5280 GYMNASTICS

PRE-APPLICATION REVIEW RESPONSE

Case Number:	13- 109775 PA	Pre-Application Meeting Date:	June 20, 2013
Process:	**Rezoning**	Date Response Prepared:	June 21, 2013

Project Name: 5280 Gymnastics Official Development Plan – Rezoning Pre Application

1 SITE PLAN

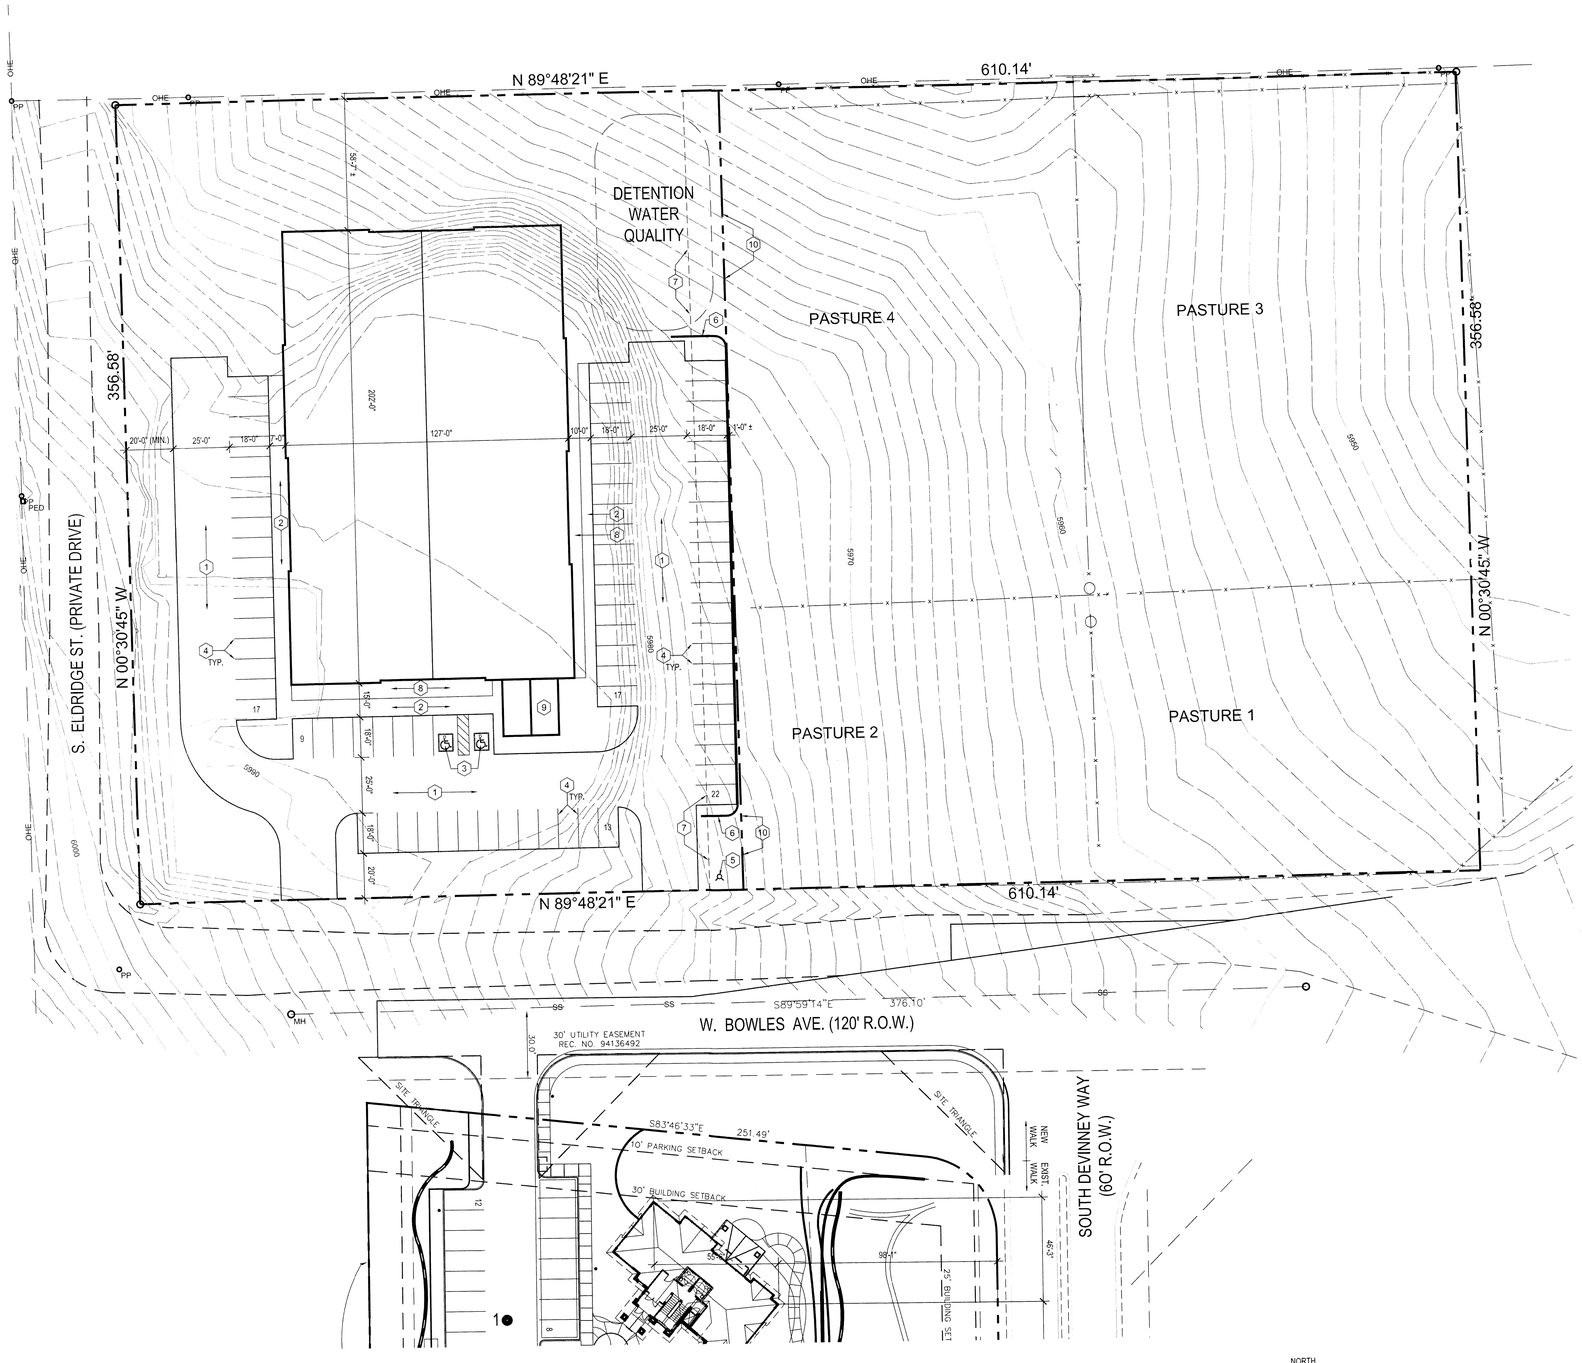
b. Parking Setbacks: The grading plan shows parking within the 6 foot parking setback. All parking spaces and loading areas shall be placed a minimum of 6 feet from any property line (Section 14.E.1 Zoning Resolution).

h. Parking Lot Stacking: The minimum distance between the parking lot and public street or right of way is 20 feet (Section 14.H Zoning Resolution). Please revise the plans to comply with the minimum stacking distance.

I was not clear whether or not the applicant was planning on subdividing as well as rezoning this property. Your preliminary development analysis summary indicates 2.25 acres, the Preliminary Site Plan states 97,278 sq. ft. and the PIN for the parcel notes 217,800 sq. ft. (5 ac.).
